30-045-20170 C M MORRIS COM A #001

HILCORP ENERGY COMPANY

Hilcorp Energy Company requests permission to P&A the subject well per the attached procedure, current and proposed wellbore schematics. The Pre-Disturbance Site Visit was held on 7/18/2019 with Bob Switzer/BLM. The Re-Vegetation Plan is attached. A Closed Loop system will be used.

PLUG AND ABANDONMENT PROCEDURE

C.M. Morris Com. "A" #1 Proposed P&A

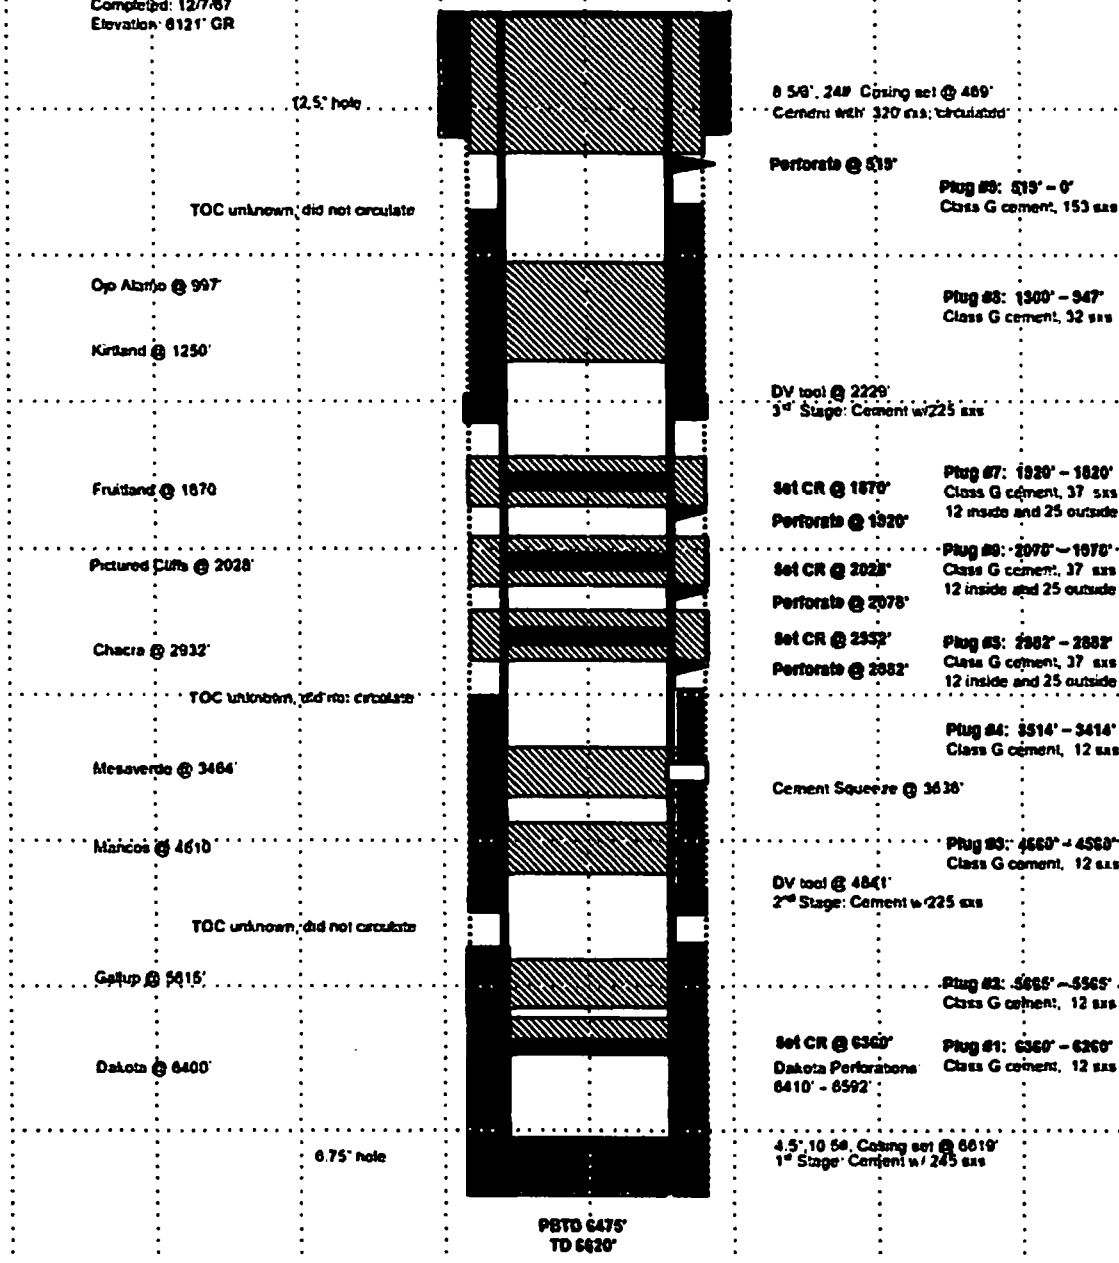
- Notify NMOCD 24hrs prior to beginning operations.
- Extend Gallup plug: 5,665'-5,454'. OCD Gallup pick @ 5,504'.
- Extend Mancos plug: 4,730'-4,560'. OCD Mancos pick @ 4,680'.
- Extend the Mesaverde plug: 3,593'-3,414'. OCD Mesaverde pick @ 3,543'.
- Extend Chacra plug: 2,982'-2,784'. OCD Chacra pick @ 2,834'.
- In addition to the BLM P.C/Fruitland plug, add a plug: 1,718'-1,678'. OCD Fruitland pick @ 1,668'.

1. Plugging operations authorized are subject to the attached "General Requirements for Permanent Abandonment of Wells on Federal and Indian Lease."
2. Farmington Office is to be notified at least 24 hours before the plugging operations commence (505) 564-7750.
3. Run a CBL from approximately 6360 to surface. Submit electronic copy of the CBL for verification to the following addresses: jkillins@blm.gov , jhoffman@blm.gov and Brandon.Powell@state.nm.us . Based on CBL results inside/outside plugs and volumes will be adjusted accordingly. Please review the General Requirements document to ensure volumes meet required excess inside and outside casing.
4. BLM pick top of the Cliffhouse at 3464 ft. Modify Plug #4 to include coverage 3414 - 3514.
5. Combine plugs #6 and #7 1820 – 2078. (PC and Fruitland)
